RE: REVIEW OF OUR FIELD SAMPLING PLAN FOR ROLL-OFFS

SUBJECT: DRAFT OU9 FIELD SAMPLING PLAN RECOMMENDATIONS - TRG-001-97

Per your telephone request of January 13, 1997, I have reviewed the draft document entitled *Field Sampling Plan To Support The Final Disposition of Soil From The Operable Unit No. 9 Source Removal Project* and dated December 1996. The following comments and recommendations are forwarded for your consideration in preparing the final document.

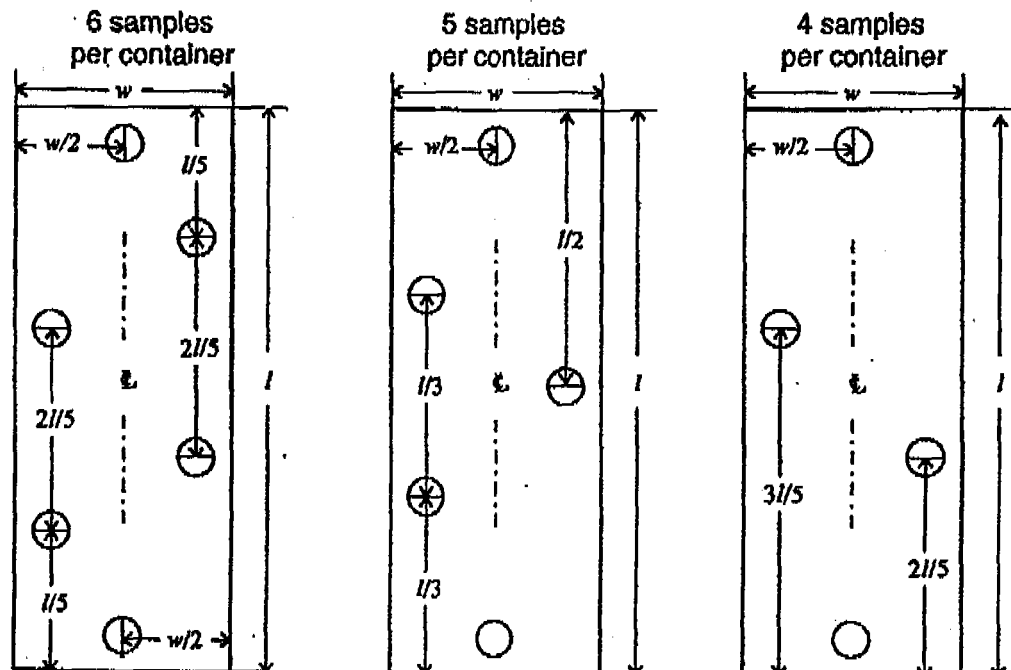
Because the soil/clay pipe mixture is not strictly homogeneous, any samples must be reasonably representative of the composite matrix. If the use of statistical analyses based upon the assumption of homogeneity in the sampled material is planned. For this reason the selected sampling technique should be one which can be expected to capture all components of the heterogeneous mixture in approximately the same proportions as exist in the sampled material as a whole. Thus, as feasible, the samples should be drawn from all depths of the roll-off containers to ameliorate the effects of settling of heavier components, if any. In addition, the samples locations should be approximately evenly spaced laterally across the horizontal cross-section of each roll-off container, with one or more taken near the longitudinal centerline and others off centerline to account for potential lateral stratification, if any. Although the plan calls for samples to be taken along the sides to eliminate the need for climbing on top of the roll-off containers, samples should be taken at some separation from the container sides, 12 or more inches as feasible, in order to avoid any segregation effects that the sides may have induced in the soil/pipe matrix components.

The use of only three composite samples, may not provide sufficient confidence that the true average concentration of radionuclides lies below the specified action levels, particularly if any of the sample results approach those levels in magnitude. However, if a minimum of four samples are analyzed and all lie below the action levels, there is greater than 90 percent confidence (actually at least 93.75% confidence) that the median value of the underlying concentration distribution is less than the specified action level, even if any or all of the sample results approach the magnitude of the action levels. If, as you expect, the observed values are all well less than the action levels, greater than ninety-five percent confidence that the average level of the entire contents is less than the action level should be easily achieved with only four samples. Such an approach would thus fully satisfy the EPA Document SW-846 criteria for mean concentration. The results also assume that the measures outlined above to ensure the samples are reasonably representative of the soil/pipe matrix have been taken.

The pattern of sample locations proposed in the draft document is regular and easily implemented but suffers from the lack of any samples taken near the longitudinal centerline and the samples in adjacent grid corners are much closer together than they should be for true independence. In addition, twelve samples are probably more than is truly necessary unless there is reason to presuppose the existence of spatially discrete areas of significantly higher contamination within the contents of a roll-off container. My understanding is that previous experience with similar excavation materials does not suggest that this would be likely. Accordingly, I recommend the use of one or more of the patterns shown below for taking samples from individual roll-off containers. The approximate locations are identified in terms of the major roll-off dimensions of length, l , and width, w . If desired, the selected sample pattern may be mirrored on alternate containers to increase randomness without degrading validity.
